PROJECT NOTES

REV	DATE	DESCRIPTION
△	10/13/2015	NOTE REVISIONS

REV	DATE	DESCRIPTION
△	02/03/16	NOTE REVISIONS

PROJECT NAME: WAITSFIELD	PLOT DATE: 10/13/2015
PROJECT NUMBER: BRF 013-4(39)	DRAWN BY: S.MERKWAN
FILE NAME: z12b136frm.dgn	CHECKED BY: T.KENDRICK
DESIGNED BY: D.KULL	SHEET 3 OF 69
PROJECT NOTES (1 OF 2)

SUBSTRUCTURE ON LEDGE

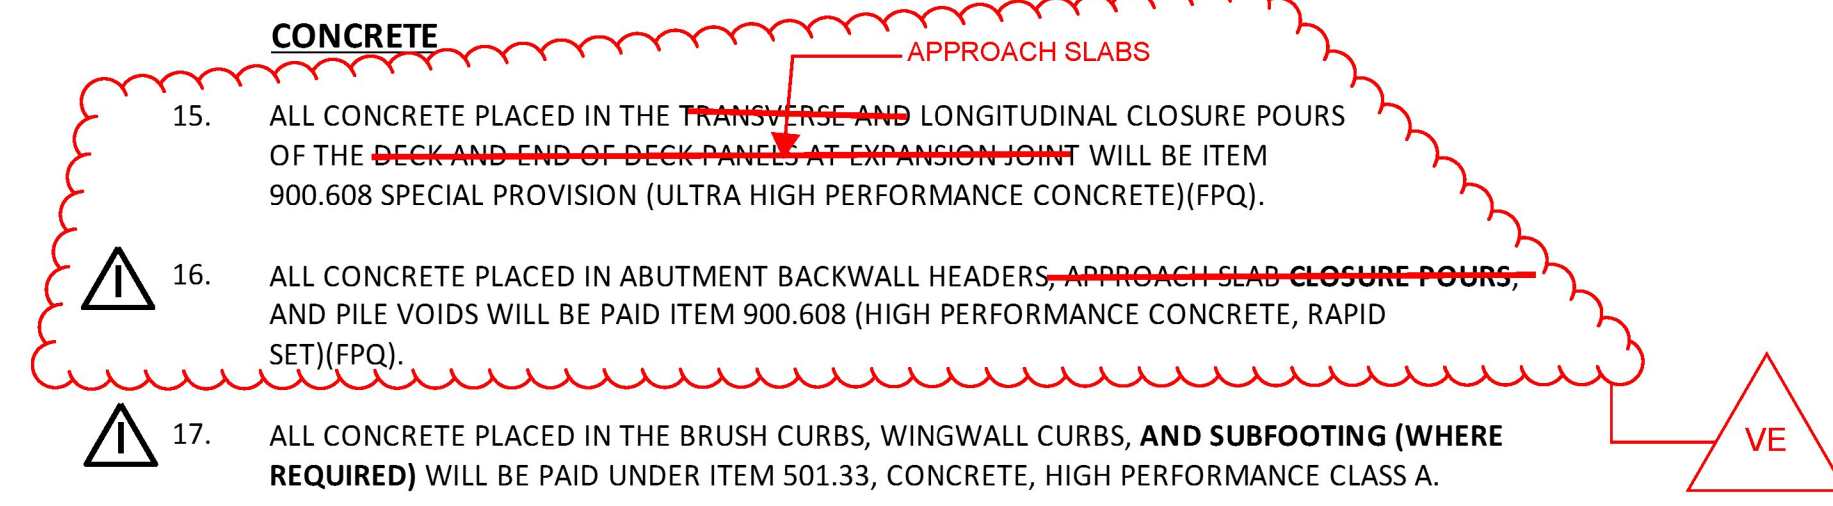
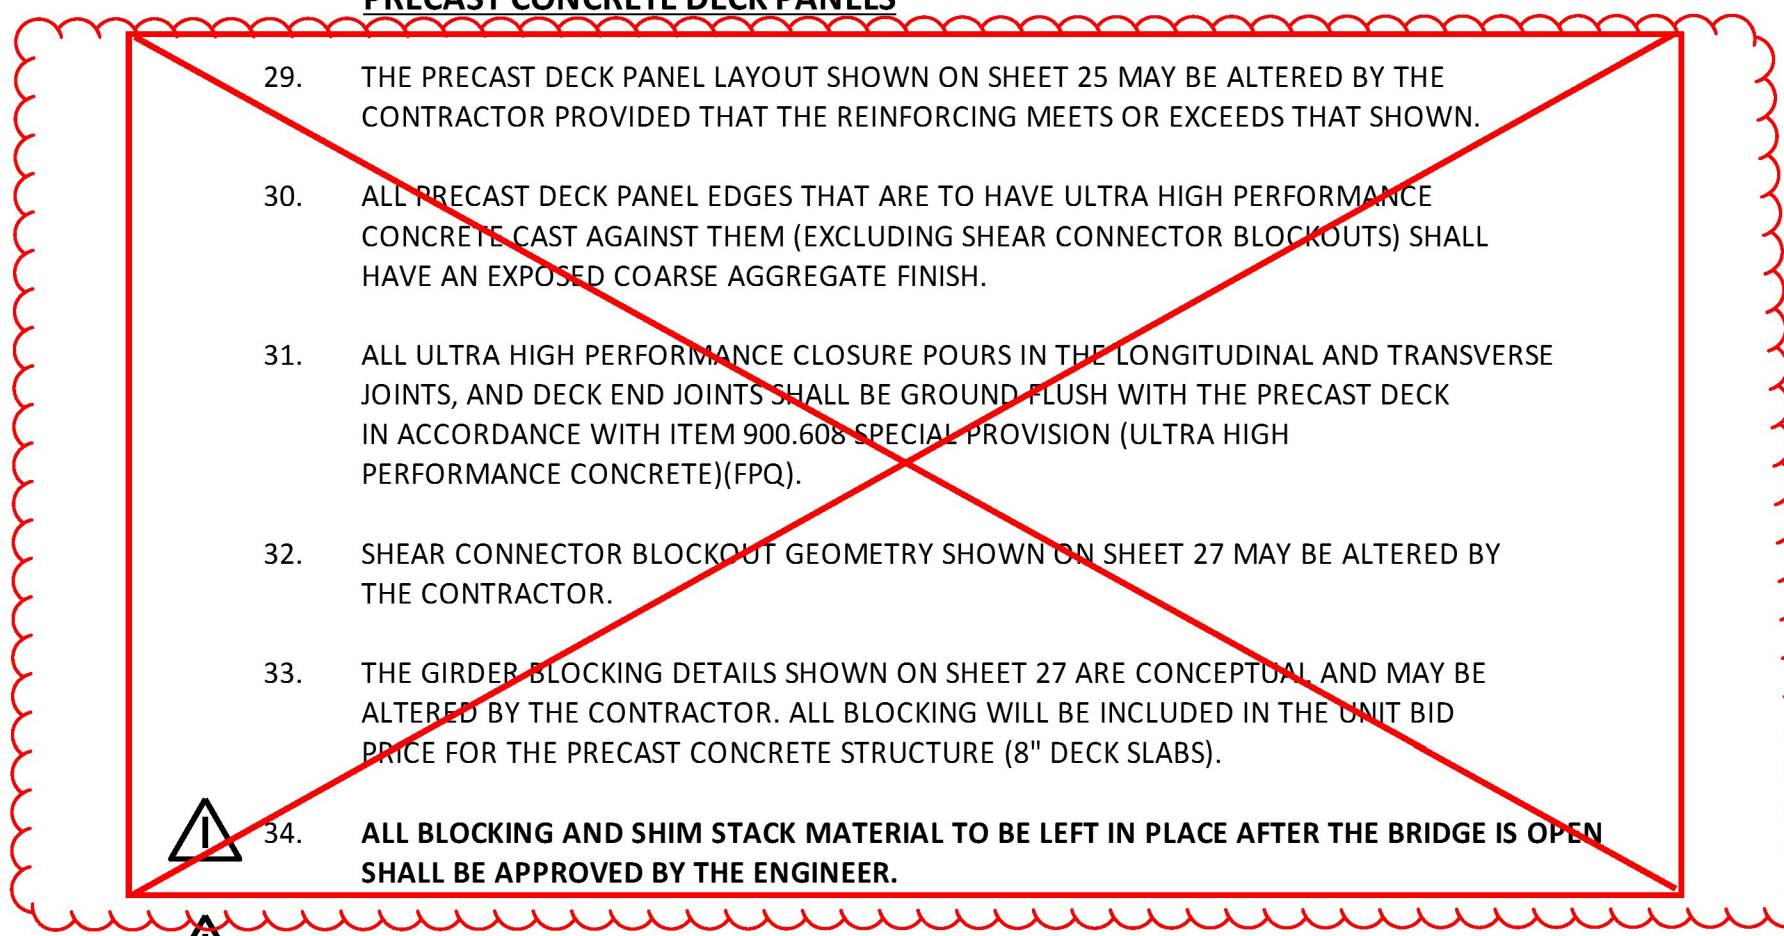
50. PRECAST FOOTINGS AT ABUTMENT 1 SHALL BE FOUNDED ON LEDGE WHICH HAS BEEN CLEANED OF ALL LOOSE ROCK AND DEBRIS TO ENSURE THAT THE SUBSTRUCTURE IS PLACED ON COMPETENT ROCK.

51. UPON COMPLETION OF THE EXCAVATION FOR ABUTMENT 1, AND PRIOR TO PLACING THE PRECAST ABUTMENTS AND PRIOR TO PLACING MATERIAL ON BEDROCK, THE ENGINEER SHALL NOTIFY THE VTRANS GEOLOGIST. THE GEOLOGIST WILL DETERMINE IF THE BEDROCK IS STABLE AND COMPETENT TO OBTAIN THE REQUIRED NOMINAL BEARING RESISTANCE. THE CONTRACTOR SHALL NOTIFY THE GEOLOGIST 24 HOURS IN ADVANCE OF WHEN THE ANALYSIS WILL BE NEEDED.

52. LEDGE THAT IS EXCAVATED FOR PLACEMENT OF THE PRECAST FOOTING (OR SUB-FOOTING IF REQUIRED) SHALL BE EXCAVATED TO PROVIDE A LEVEL SURFACE OR AS DIRECTED BY THE ENGINEER. **THE SUBFOOTING (WHERE REQUIRED) SHALL HAVE A RAKED FINISH.**

53. **ABUTMENT 1 HAS BEEN DESIGNED FOR THE TOP OF FOOTING ELEVATIONS SHOWN ON THE PLANS. LEDGE SHALL BE EXCAVATED DOWN TO THE INDICATED BOTTOM OF FOOTING, INCLUDING 3" MIN GROUT BED, FOR THE FULL WIDTH (TOE TO HEEL) OF THE CONFIGURATION. IF THE LEDGE ELEVATION IS GREATER THAN 6" BELOW THE DESIGN BOTTOM OF FOOTING, A SUBFOOTING SHALL BE POURED SO THAT THE DESIGN TOP OF FOOTING IS AT THE REQUIRED ELEVATION. THE GROUT BED WILL BE PAID UNDER THE APPROPRIATE SECTION 540 CONTRACT ITEM. THE SUBFOOTING, IF REQUIRED, WILL BE PAID UNDER ITEM 501.33 "CONCRETE, HIGH PERFORMANCE CLASS A."**
